# Access Compliance Report

## Public Rights-of-Way

| Intersection ID: 52956                  | Main Street: OLD_POST_RD | Cross Street: CONFERENCE_DR             | Location: SE           |
| ADA ID: C87588444086                    | Ramp Type: Perp          | Initial Pass/Fail: Fail                 | Overall Compliance: No |

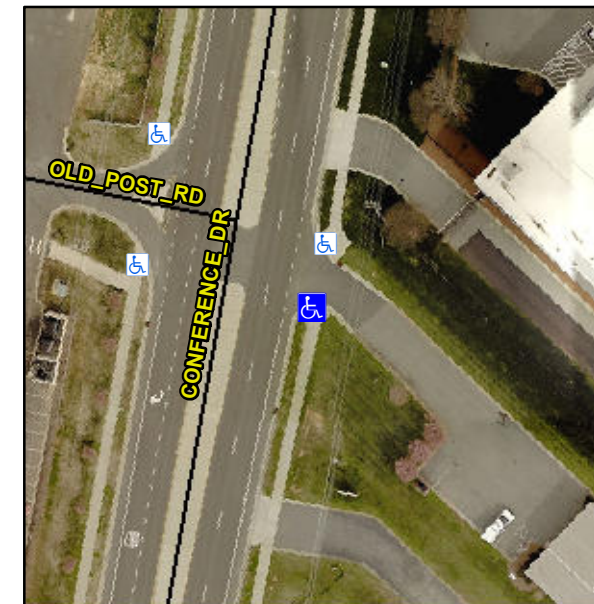
**Not Found, R304.5.3**

| Compliance | Description           | Data  | Compliance | Description                 | Data |
|------------|-----------------------|-------|------------|-----------------------------|------|
| Yes        | Ramp Width (in)       | 48.0  | No         | Ramp XSlope (%)             | 5.3  |

**Remove & Replace Entire Ramp.**
